Date: September 16, 2010
Refer To: ENV-RCRA-10-175
LAUR: 10-06070

SUBJECT: LOS ALAMOS NATIONAL LABORATORY, NPDES PERMIT NO. NM0028355, NOTICE OF PLANNED CHANGE AT NPDES OUTFALL 051

1000 GAL. TANK PARTIAL PIPING - ISOMETRIC
SCALE NONE

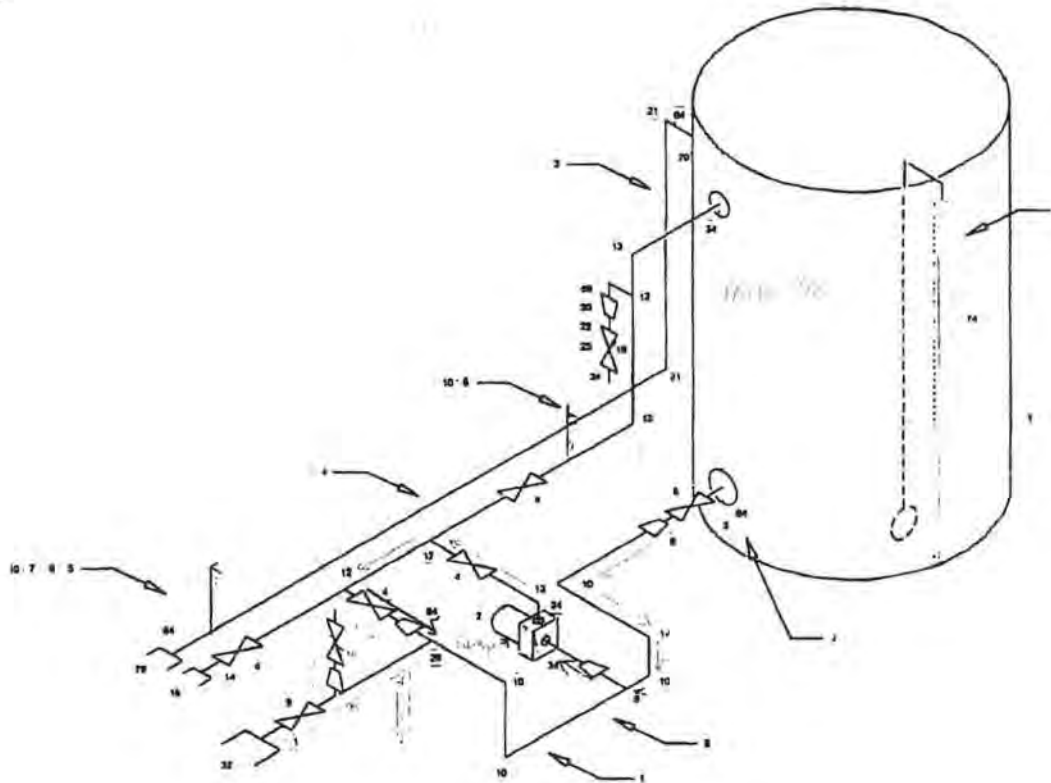
been re-circulated for 80 minutes at a rate of 50 gpm. If discharge to the outfall is from Tank 38, a new NPDES compliance sampling location is proposed. This location will be in Room 38, on the discharge side of the pump that will pump the Tank 38 contents to the outfall. Enclosure 1 shows an isometric drawing of Tank 38, associated piping, recirculation/discharge pump, proposed NPDES sampling location and flow paths during discharge to Outfall 051. If discharges to Outfall 051 are made from the Frac tanks, the presently approved NPDES compliance sampling location in Room 116 at the RLWTF will continue to be used.
